report group: Playground Inspection
title: 7003 Falling Water Dr. Spring, Tx 77379
created: 12/20/22, 11:20 AM
modified: 12/21/22, 9:57 AM
item count: 21

Scope of the playground safety inspection:
the play equipment was inspected against the current CPSC public playground Safety Handbook and ASTM F1487-17. Any equipment that was not in compliance will be reported in this inspection report and the standard will be cited. Any items that the inspector found to be in compliance but that may need to be monitored will also be noted.

report group: Compliant Park Inspection
title: 7003 Falling Waters Dr. Spring, Tx 77379
created: 3/10/23, 9:10 AM
modified: 3/17/23, 9:32 AM
item count: 6

(4)

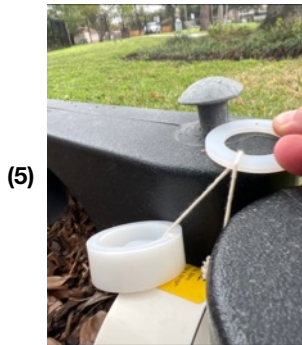
ASTM F1487 6.4
-there shall be no entanglement hazards on public play equipment.
CPSC 3.6 Tripping Hazard
-play areas should be free of tripping hazards to children who are using a playground. two common causes of tripping are anchoring devices for playground equipment and containment walls for loose fill surfacing materials.

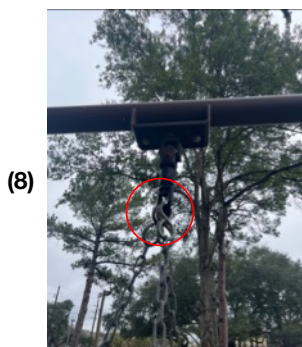
created: 12/20/22, 11:51 AM
modified: 12/20/22, 11:51 AM
taken by app: Yes
description: Impalement/entanglement/tripping hazard

[ASTM F1487 6.4](#)

-there shall be no entanglement hazards on public play equipment.

[CPSC 3.6 Tripping Hazard](#)

-play areas should be free of tripping hazards to children who are using a playground. two common causes of tripping are anchoring devices for playground equipment and containment walls for loose fill surfacing materials.

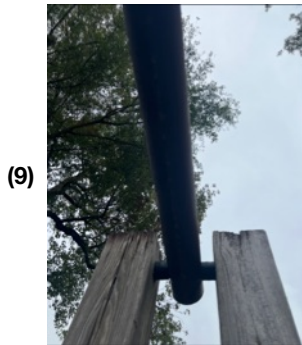
[ASTM F 1487 6.4.5 Connecting Device](#)

-connection device such as, but not limited to, S-hooks and C-hooks, when properly closed, are not entanglement hazards. these connectors are considered closed when there is no gap greater than .04 inches.

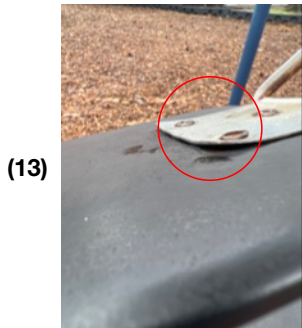
created: 12/20/22, 11:57 AM
modified: 12/21/22, 9:57 AM
taken by app: Yes
description: S-hook non-compliant
Paint chips/rust

ASTM F1487 4.1.1

-Metals subject to structural degradation such as rust or corrosions shall be painted, galvanized, or otherwise treated.

ASTM F1487 6.4.5.1

-No portion of the closed end of an S-hook lower loop may project beyond the vertical boundary established by the upper loop.

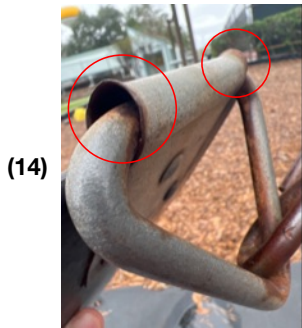
CPSC 3.4

- Exposed open ends of all tubing not resting on the ground or otherwise covered should be covered by caps or plugs.
- Wood Parts should be smooth and free from splinters
- All corners, metal and wood, should be rounded
- All metal edges should be rolled or have rounded capping
- Prevent injuries caused by splintered wood, sharp points, corners, or edges that may develop as a result of wear and tear on equipment.
